Ohio Department of Transportation

# FRA-161-15.80 Noise Walls – 81” Barrier Drainage An

PID 117607

March 27, 2024

**SCHEMATIC PLAN WITH 81" BARRIER DRAINAGE AREAS AND SPREAD CALC SUMMARIES**  
 STA. 2122+00.00 TO STA. 2172+00.00

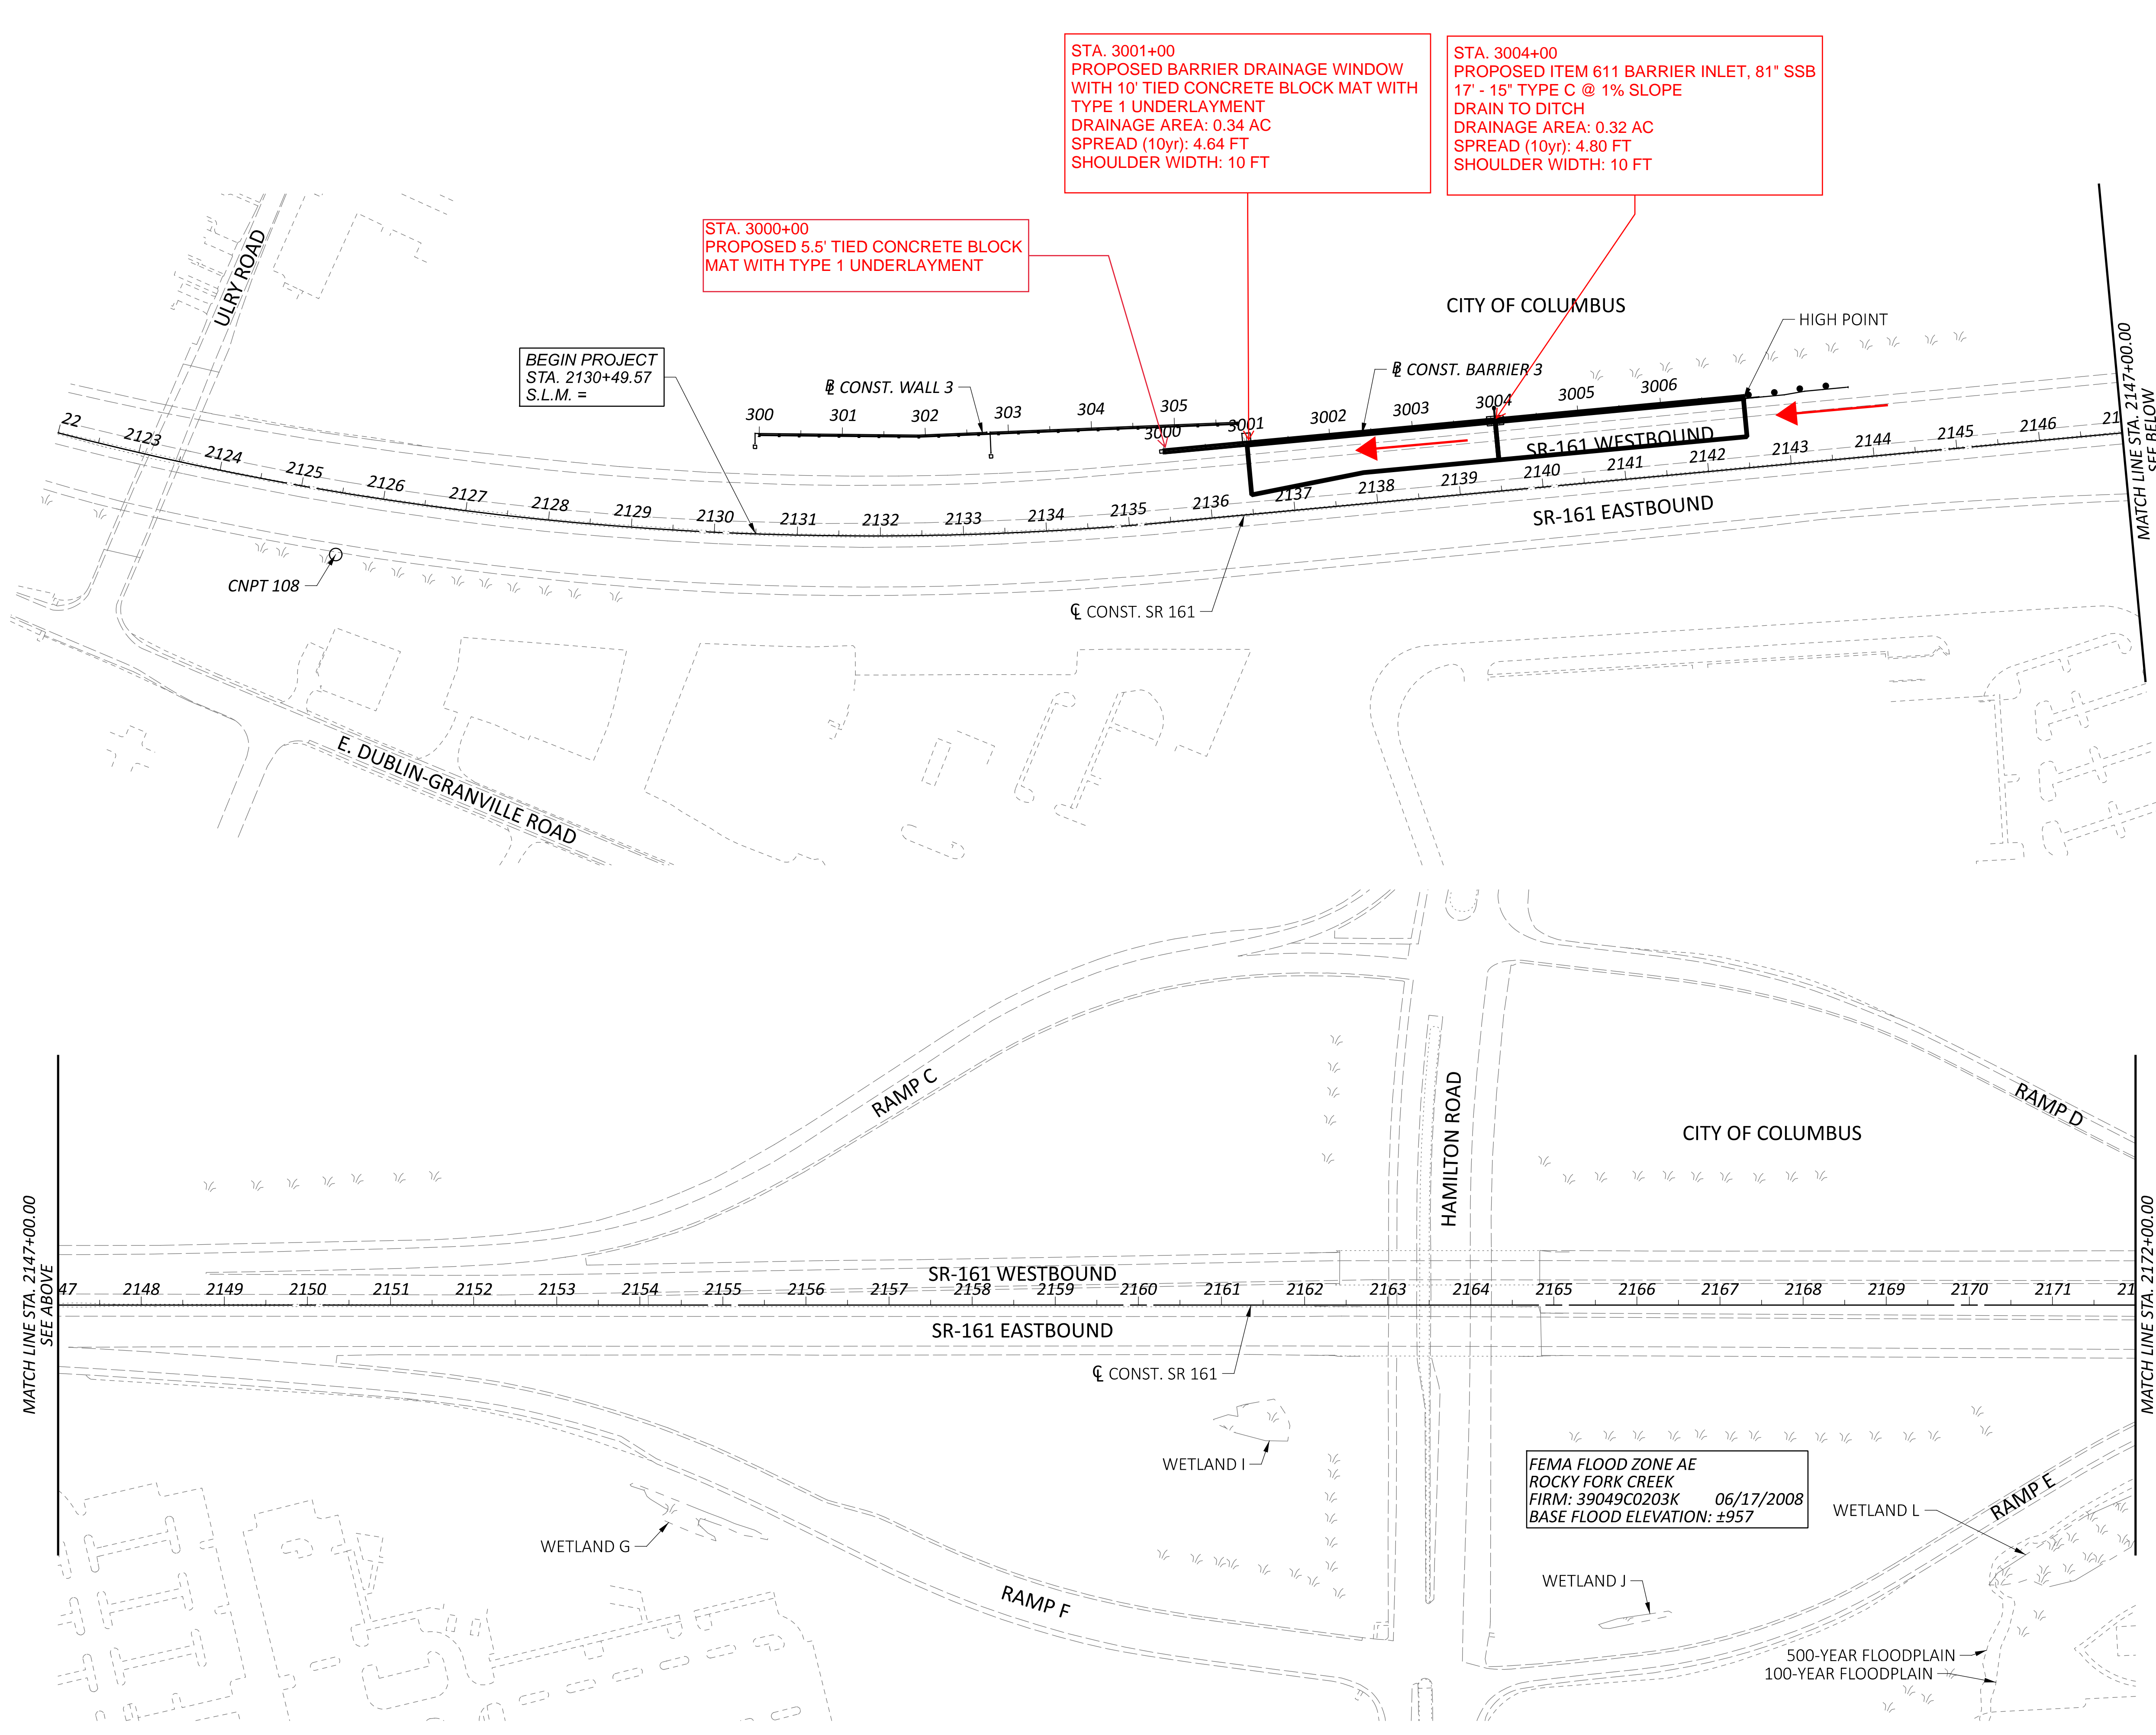
Locations without a window should not be analyzed as an I-2-10. The best option in CDSS is to analyze as a CB-3A. Apply throughout the inlet spacing calculations. A new preliminary SCD which also includes a window has been developed for use with 81" barrier and will be published in July. The drawing is available in PW for use in the plans. We will defer to the project team.

Is this remaining at 4" or increasing to 6"? 6" height recommended due to clogging concerns.

0% slope may create issues conveying flow through the window, however, conservatism in placing per spread appears to have been considered in the design. Will defer concerns to COC if they are maintaining.

ARCADIS  
RESPONSE:  
COMPLIED

ARCADIS  
RESPONSE:  
REVISING TO  
6" AND A NEW  
DETAIL HAS  
BEEN  
PROVIDED

ARCADIS RESPONSE: COC HAS ACCEPTED MAINTENANCE (PLEASE SEE NEXT SHEET FOR REFERENCE)

**SCHEMATIC PLAN WITH 81" BARRIER DRAINAGE AREAS AND SPREAD CALC SUMMARIES**  
 STA. 2222+00.00 TO STA. 2272+00.00

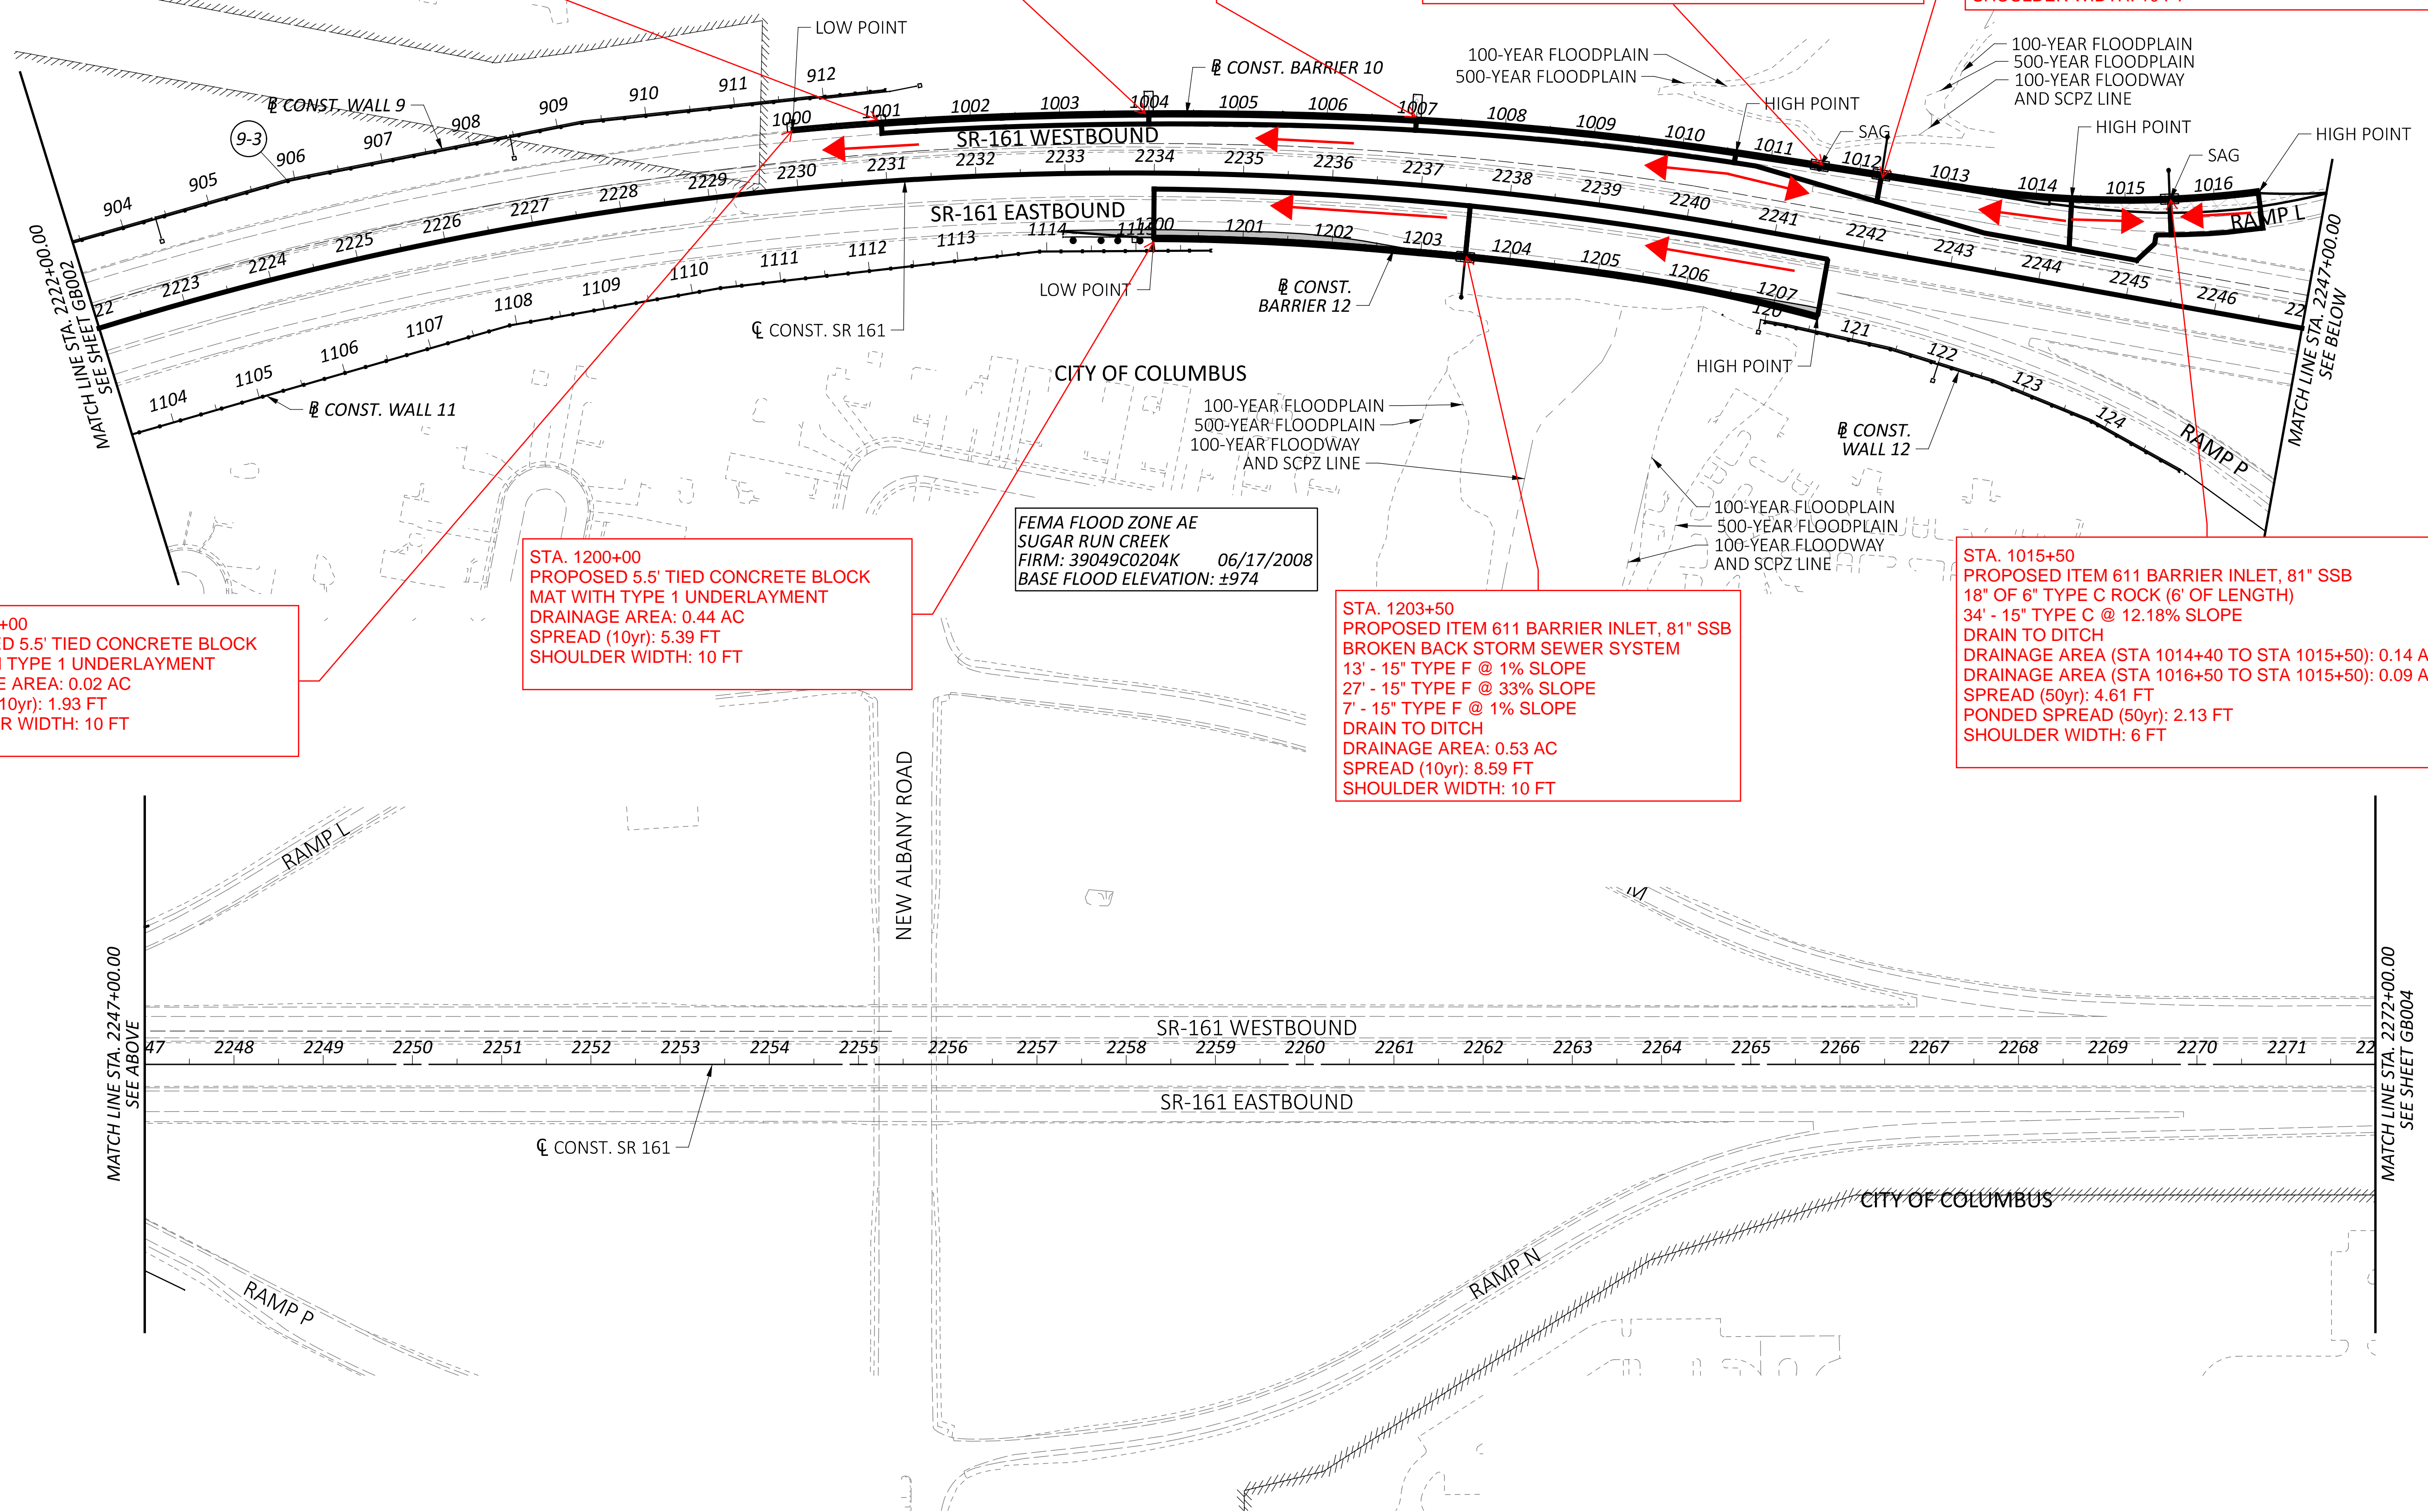
Consider analyzing broken back conduits in three sections to outlet. Verify outlet RCP not required. MHs can be used to represent bends. Apply to both broken back locations.

ARCADIS RESPONSE:  
COMPLIED.
